SI B52 09 15
Seats

This Service Information bulletin supersedes SI 52 09 15 **dated October 2015.**

NEW Recall 15V-XXX: ISOFIX Bracket

F10 (5 Series Sedan)

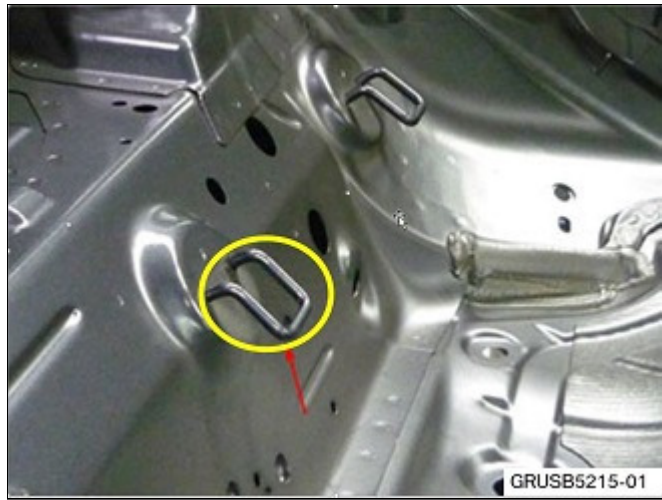
NEW Inboard bracket (anchor) in the left rear seating position may be deformed.

NEW Inboard bracket (anchor) in the left rear seating position must be adjusted into correct position.

<ol style="list-style-type: none"> 1. Check the gap on the right side bracket of the left side rear seat. <p>The bracket to be checked is shown.</p>
--	---

2. Check the gap between the seat bottom and ISO bracket using an appropriate measuring tool.

Note: The seat bottom to bracket gap must be 4 mm to 6 mm.

3. If the gap is not correct, adjust the bracket by bending the uprights.
4. After the rework, recheck the gap measurement.
